BYLAW C-7991-2020

A Bylaw of Rocky View County, **in the Province of Alberta, to adopt** the Ascension Conceptual Scheme

SCHEDULE 'A'
FORMING PART OF BYLAW C-7991-2020

A Conceptual Scheme affecting Block 6, Plan 8710757, NE-18-25-2-W5M; Block A, Plan 9212196, SE-19-25-2-W5M; a portion of SE-19-25-2-W5M; and SW-19-25-2-W5M, herein referred to as the Ascension Conceptual Scheme.

Figure 14 - Internal Transportation Plan

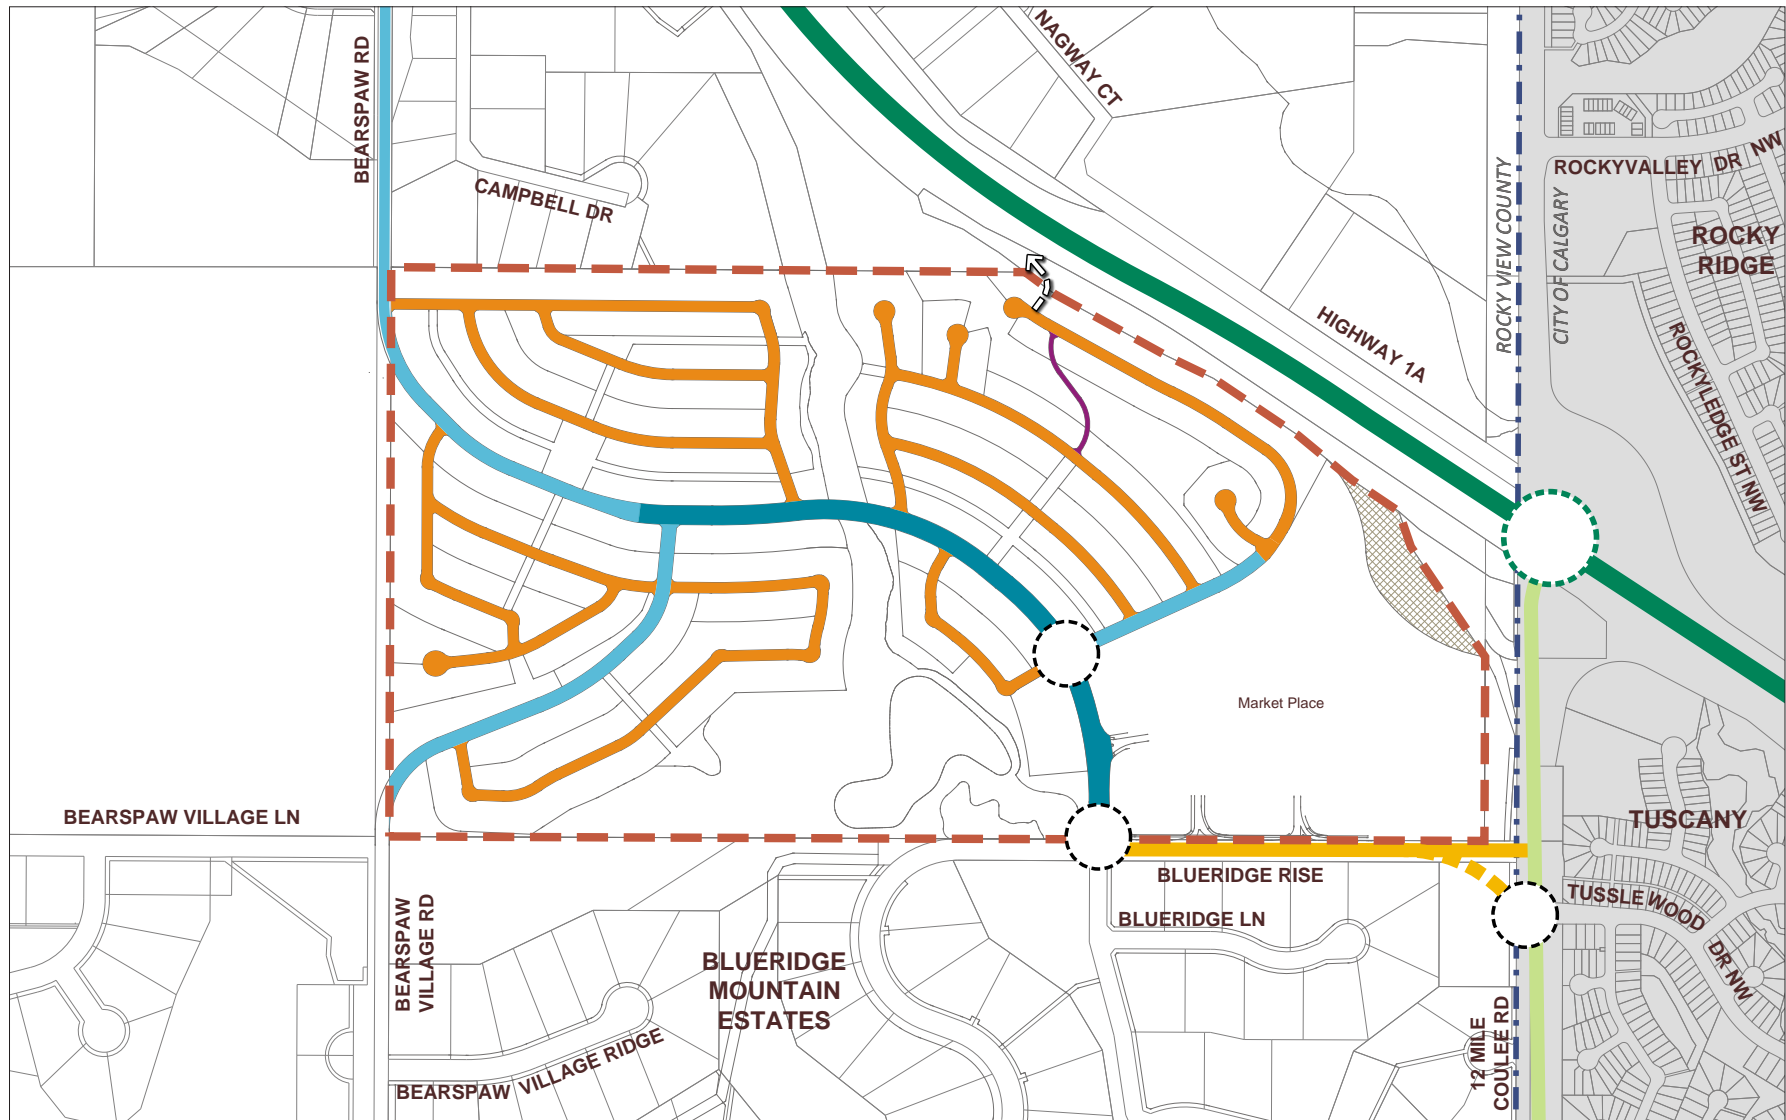
Figure was updated

The development contains ~~four~~**three** different road designs as illustrated on **Figure 14 – Internal Transportation Plan**.

Figure 15 - 27m Urban Primary Collector

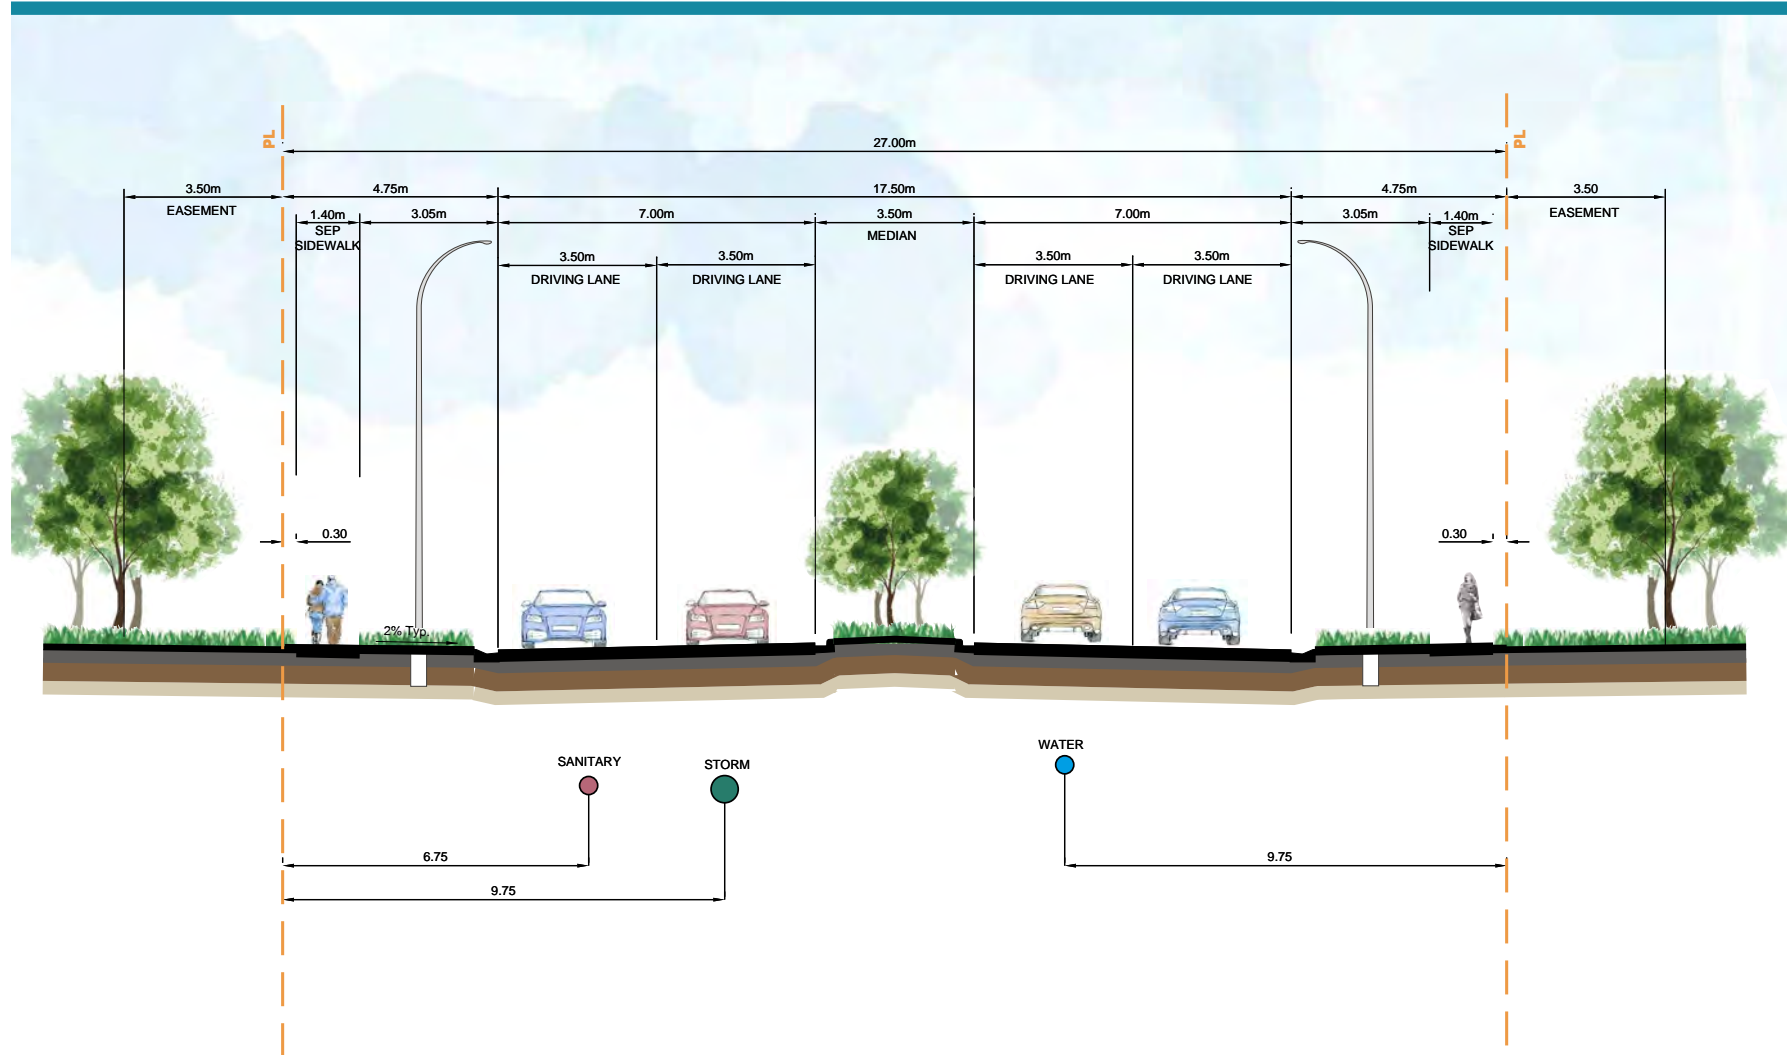
Figure was updated, Formerly "Grand Boulevard Road Design"

The design for the Grand Boulevard should be guided by **Figure 15 - ~~Grand Boulevard Road-Design 27m Urban Residential Collector~~**, in alignment with Rocky View County classifications.

Figure 16 - 20m Urban Residential Collector

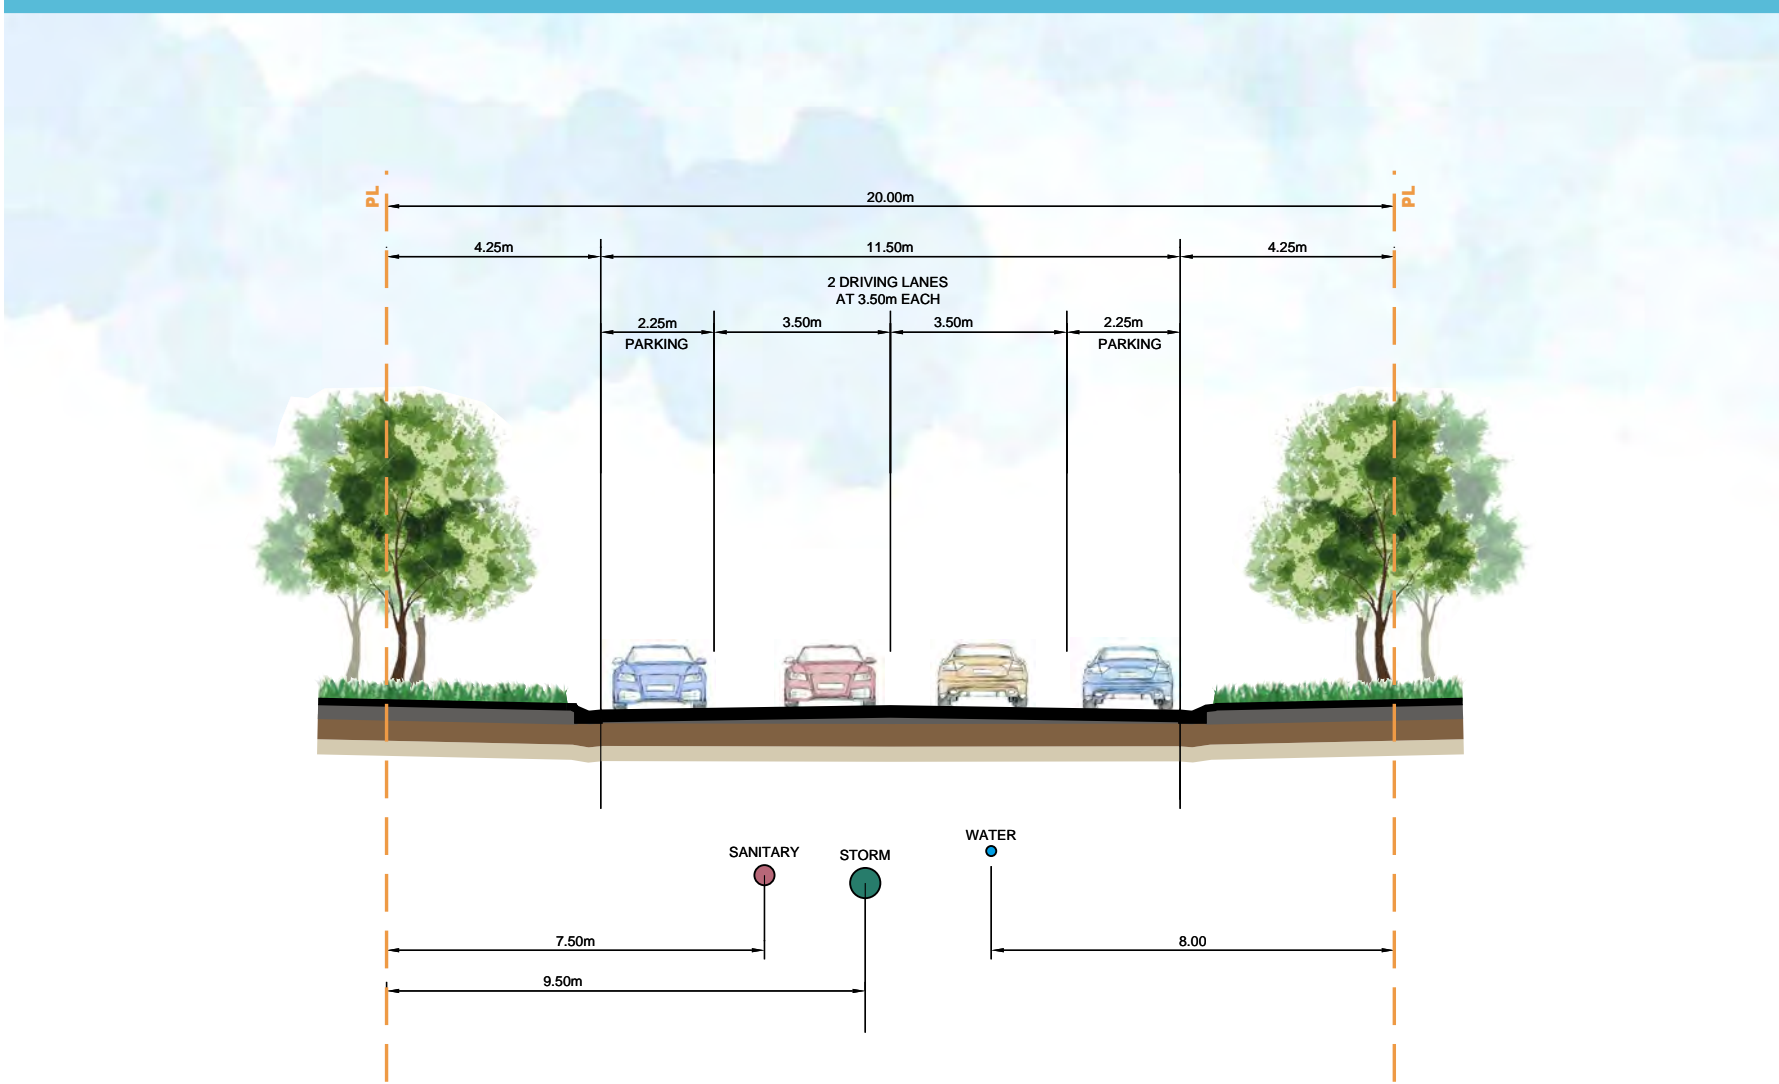
Figure was updated, Formerly "Collector Road Design"

The cross-section design for Collectors should be guided by **Figure 16 - ~~Collector Road-Design 20m Urban Residential Collector~~**, in alignment with Rocky View County classifications.

Figure 17 - 15m Urban Residential

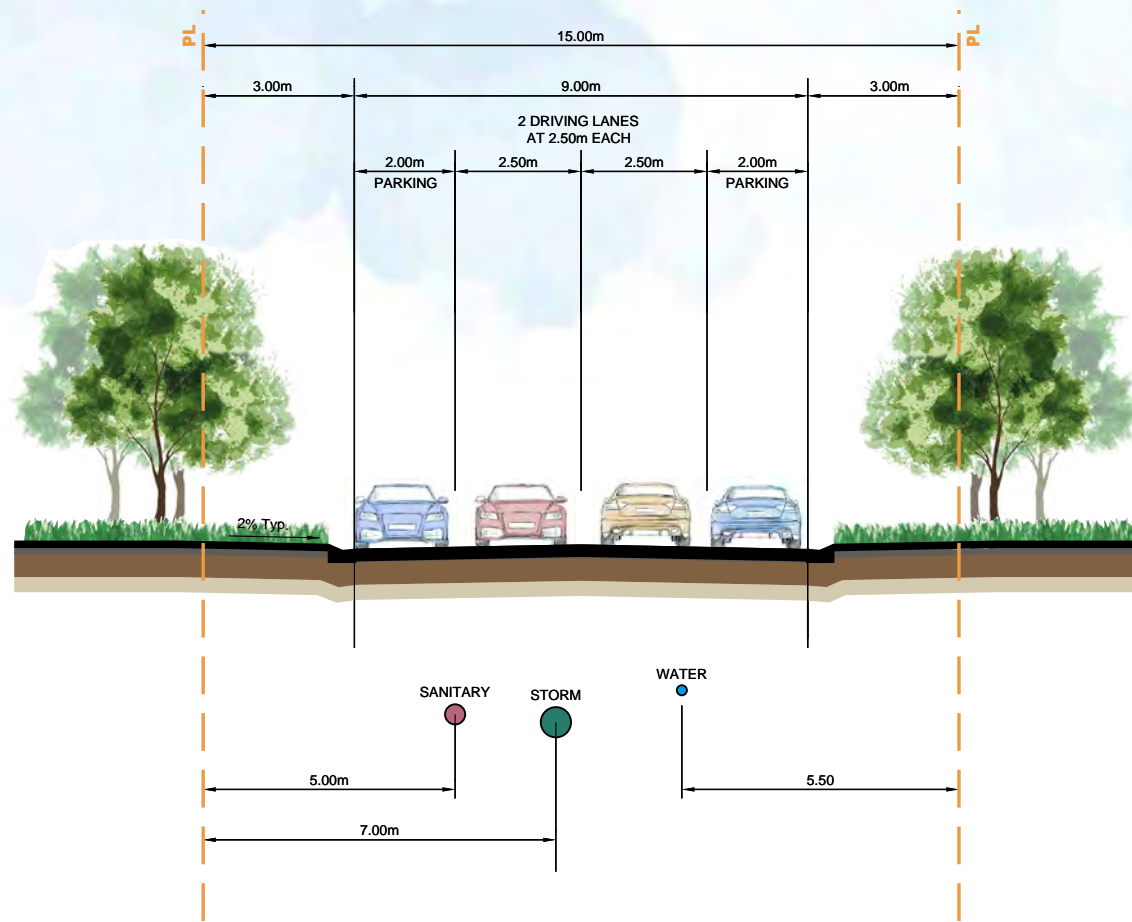
Figure was updated, Formerly two Figures "Single-Loaded Residential Road Design" & "Double-Loaded Residential Road Design"

The cross-section design for residential road right-of-ways should be guided by **Figure 17 - ~~15m Urban Residential~~**, in alignment with Rocky View County classifications.

Figure 18 - Regional Storm Water Servicing Plan

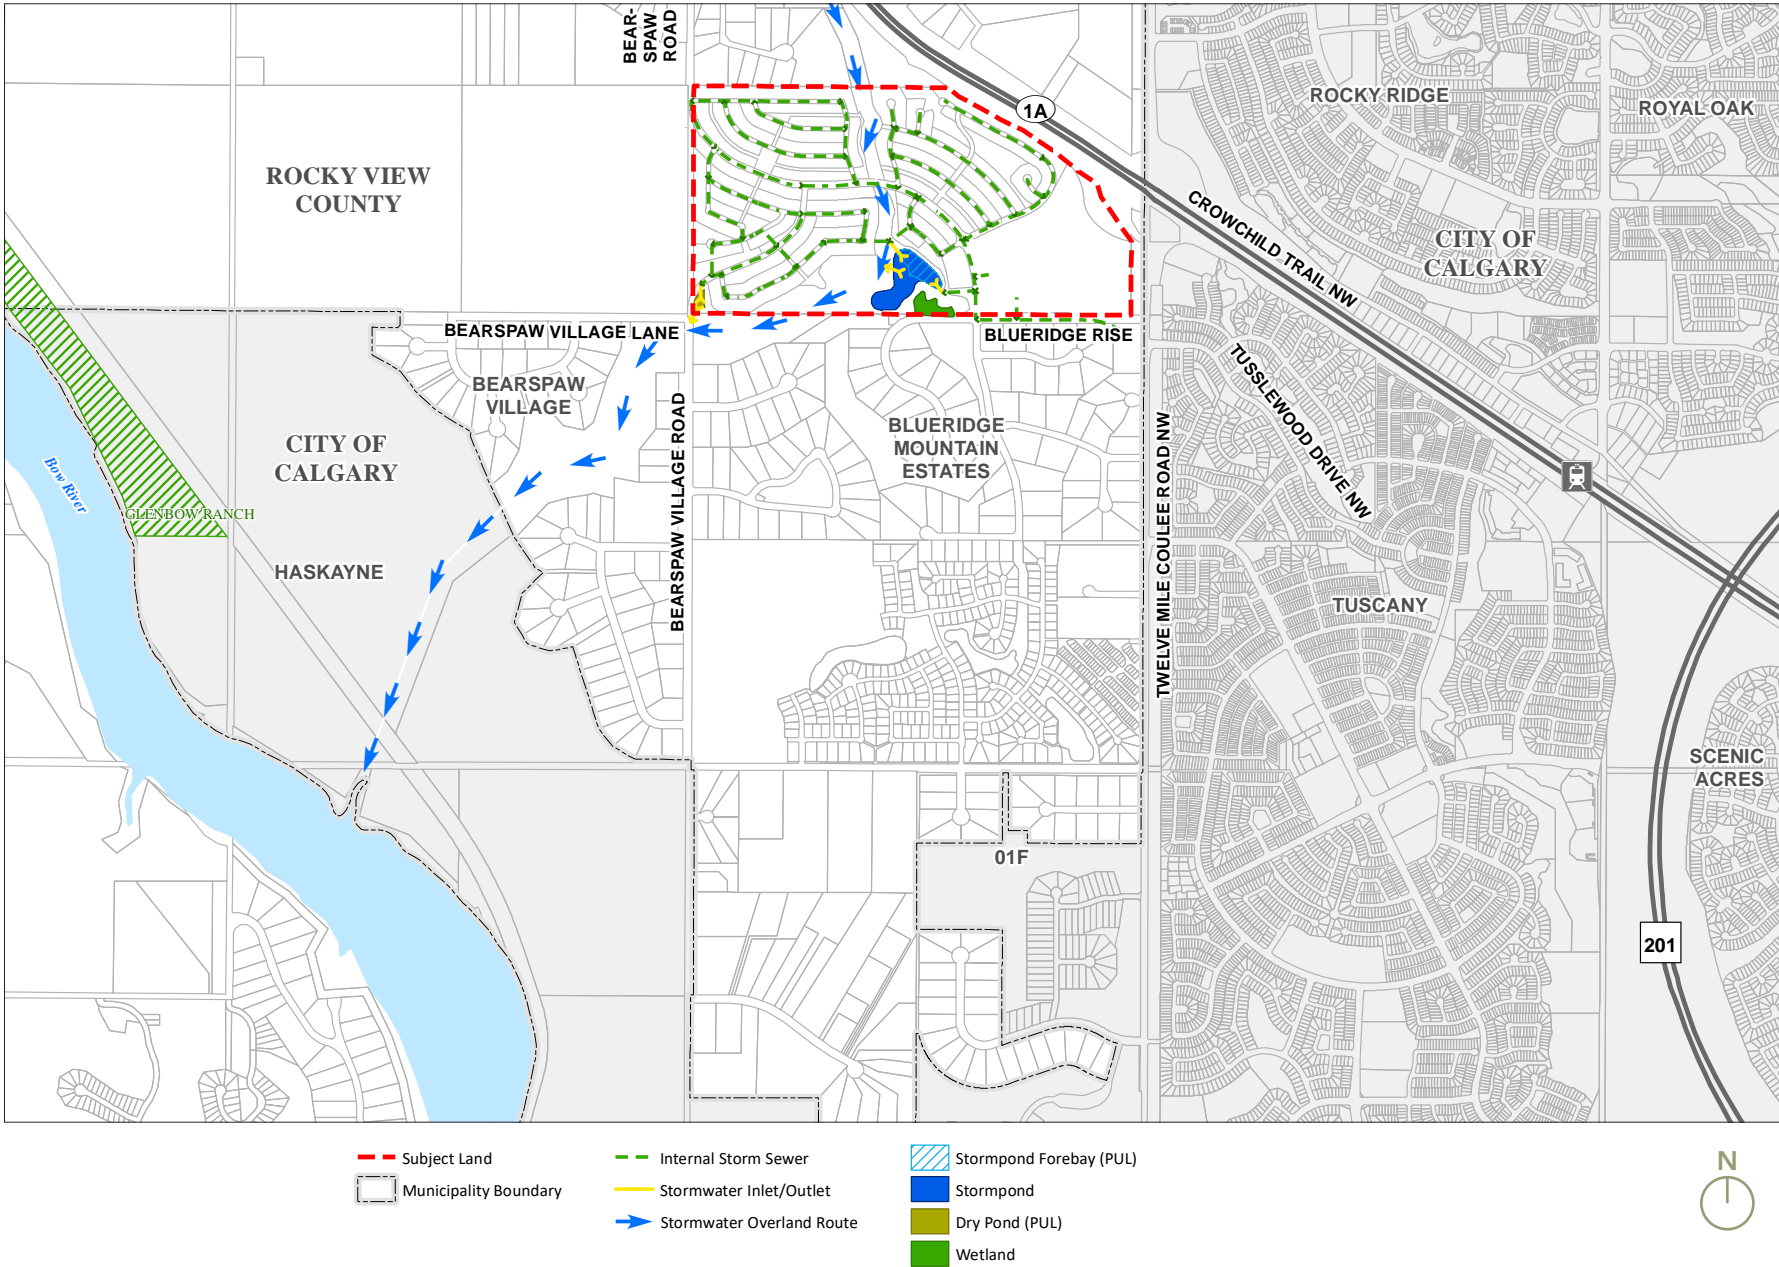
Formerly Figure 19 - Figure was updated
